**Town of Lake Park, Florida**  
**Special Call Planning and Zoning Board Meeting**  
**Agenda**

Monday, September 11, 2023 at 6:30 PM

**TOWN LAKE OF PARK  
PLANNING & ZONING BOARD  
STAFF REPORT  
MEETING DATE: September 11, 2023  
PZ-23-06**

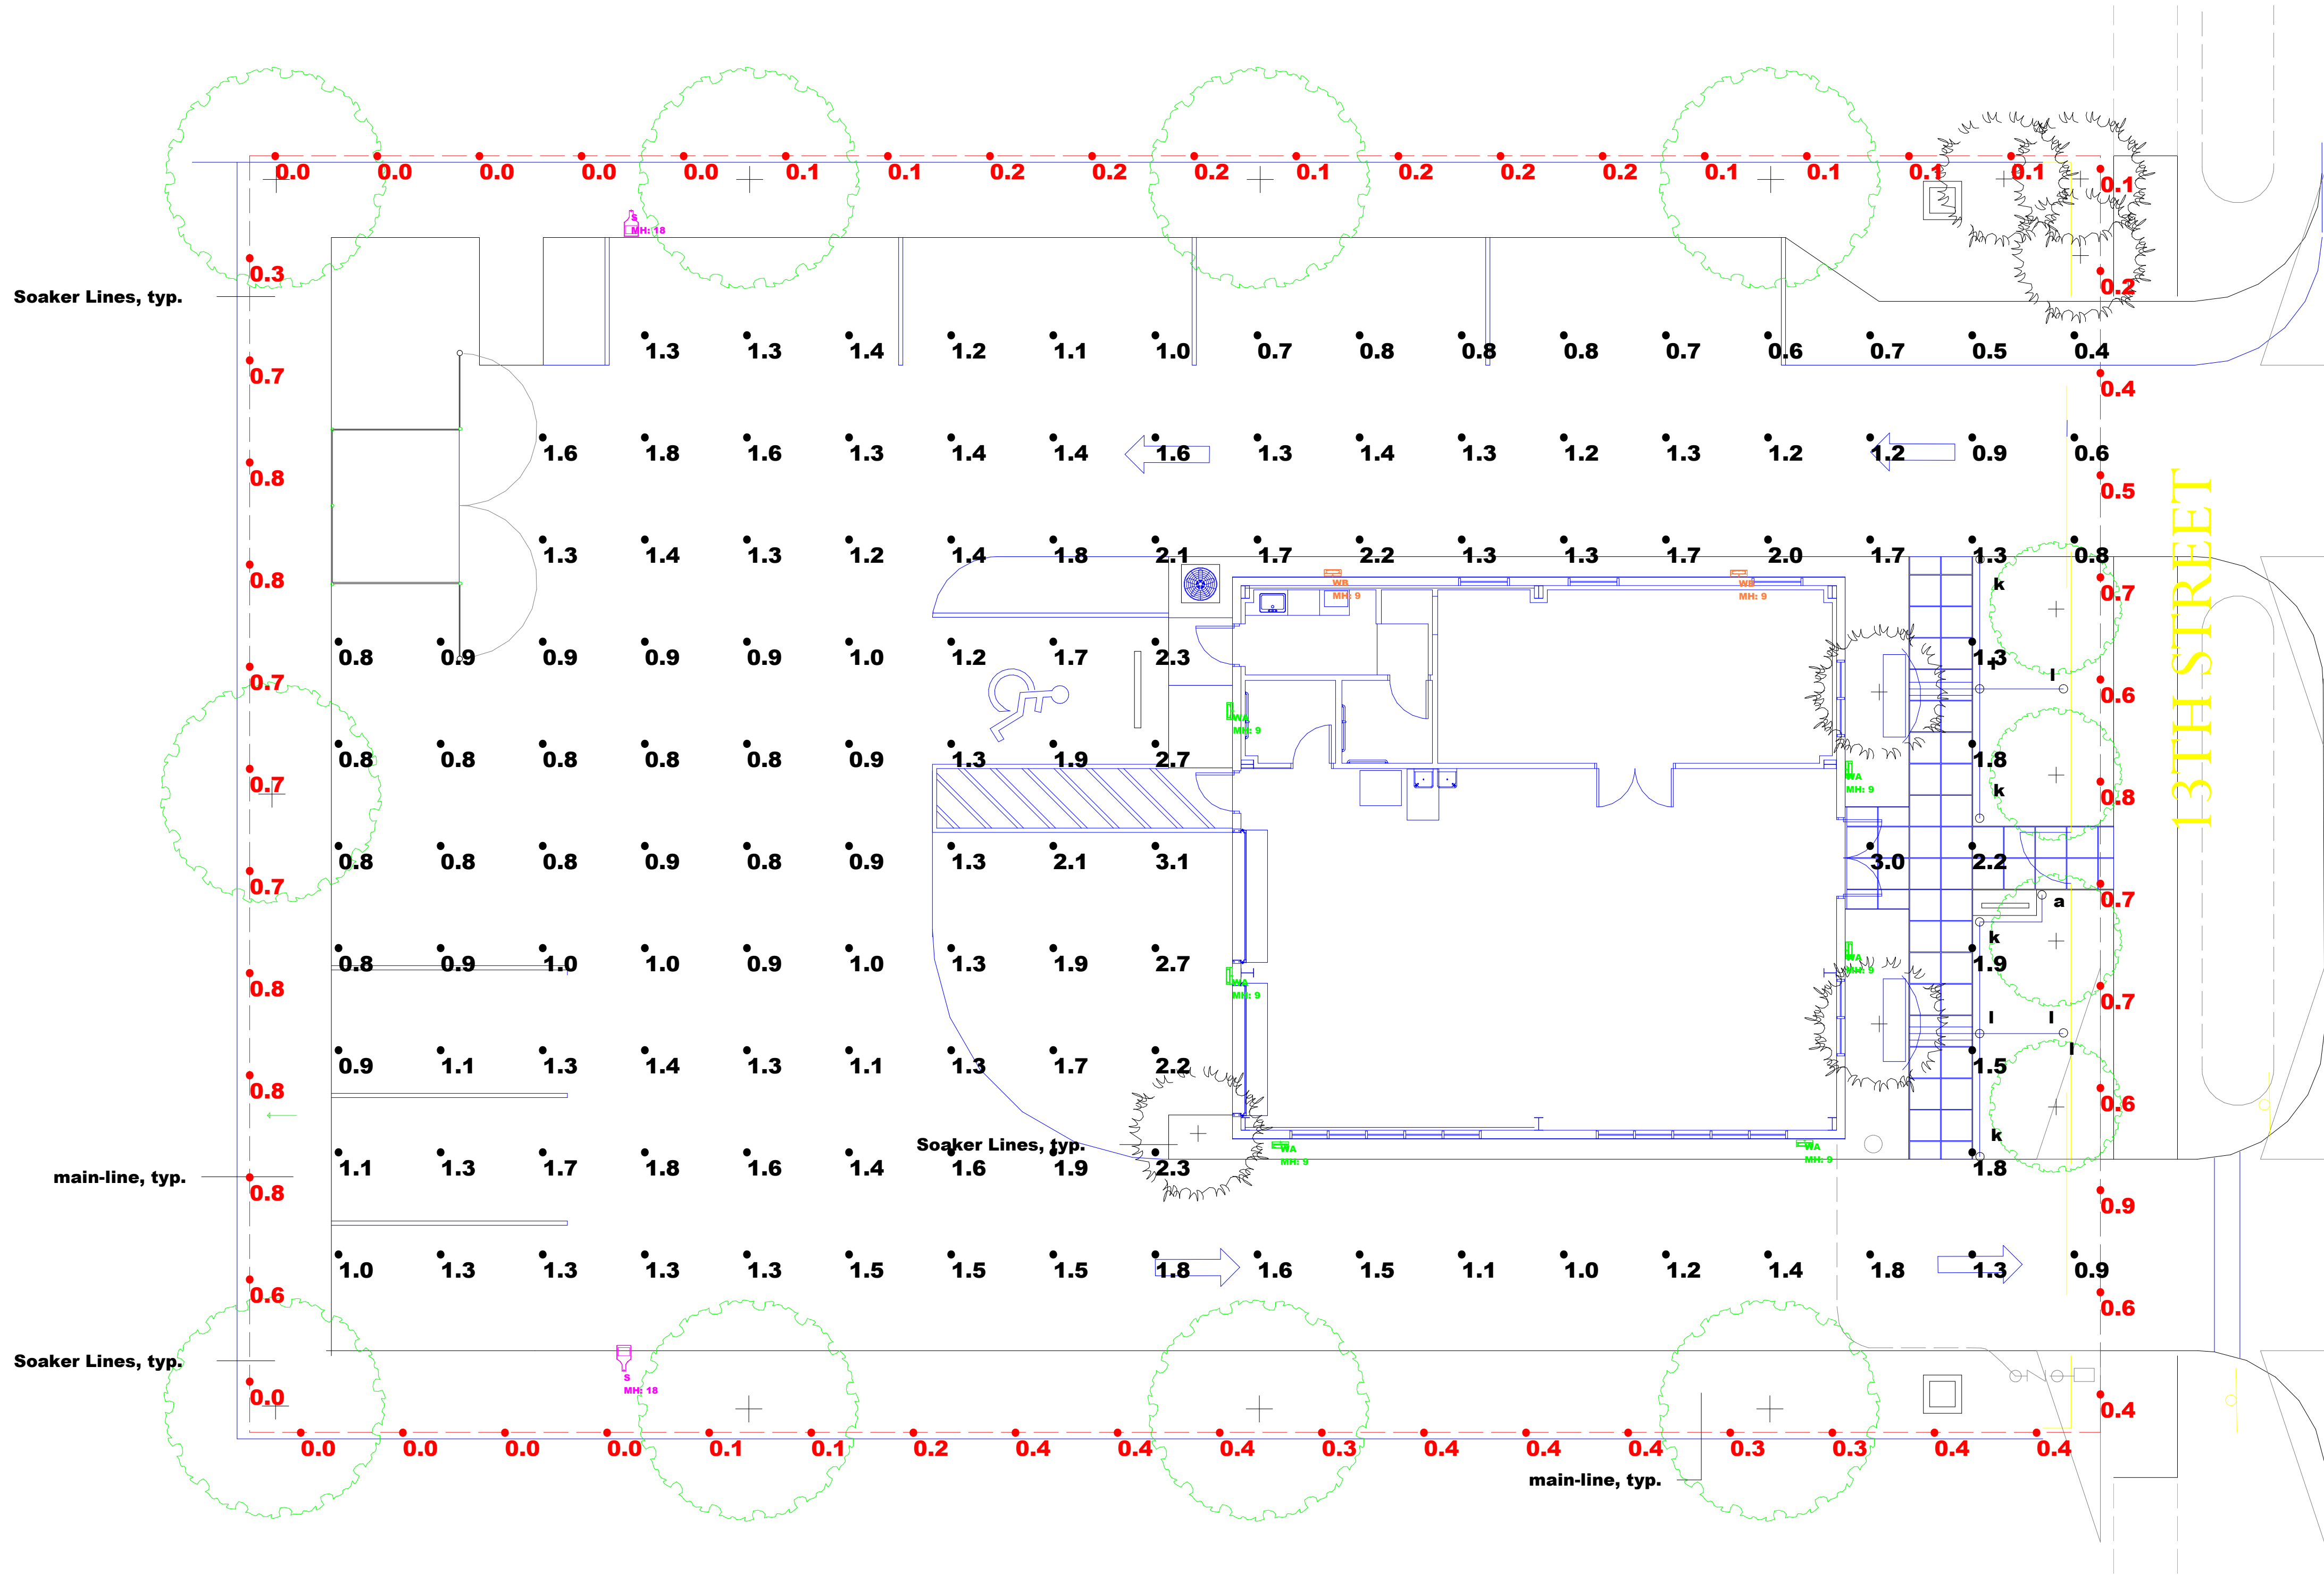
Comment: There might need to be some "island striping" or striping, just to guide vehicles on the correct path to execute the turns. An autoturn with the landscape trailer would be useful.

**Response: Perimeter striping along the edge of the AutoTurn route has been added to assist truck with making the turns.**
